MILPITAS PLANNING COMMISSION AGENDA REPORT

TITLE: **VARIANCE P-VA2003-2 and "S" ZONE APPROVAL-AMENDMENT P-SA2003-61**

Proposal: A request to exceed the maximum allowed impervious surface coverage in order to accommodate wood decking and other back yard amenities for a single family hillside residence

Location: 510 Vista Spring Court (APN 42-30-017)

Basketball Court 670 sq. ft

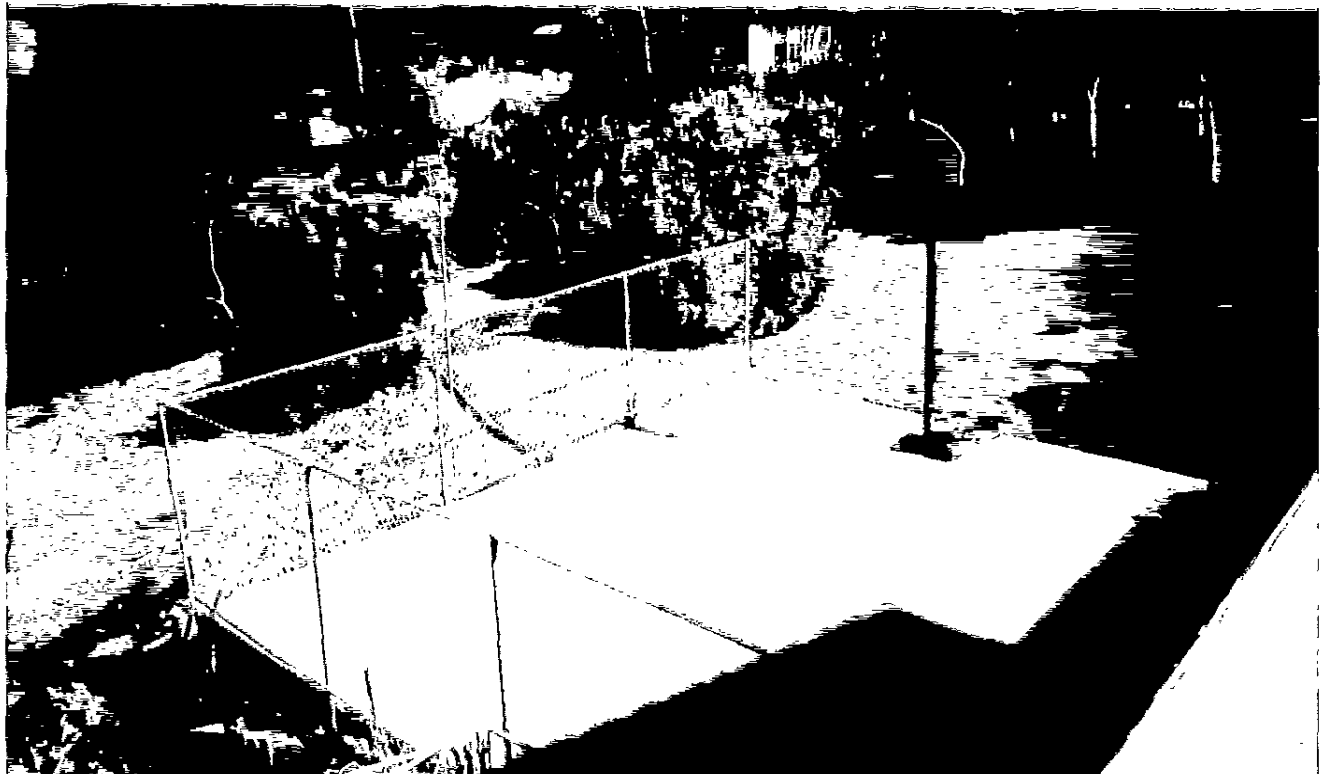
The City's Hillside ordinance specifies that no artificial lighting is permitted for outdoor sports courts (MMC sec. XI-10-45.15-1). A pole light has been installed at the sports court on the side of the house. If the variance and "S" Zone applications for the back yard/side yard amenities are approved,

Chain link fencing (approx. 5 feet tall) was installed around portions of the sports court and the adjacent paved area (dog run). This fencing type requires Planning Commission approval. Also, the Hillside ordinance requires that recreation courts be landscaped and screened so as to be unobtrusive from off-site (MMC sec. XI-10-45.14-2). If the Planning Commission approves the variance and the chain link fencing, staff recommends additional landscaping be installed along the front and east side of the sports court, per the ordinance requirement.

thus allowing these amenities to remain, then the light(s) must be removed, or a new variance application submitted addressing this code section.
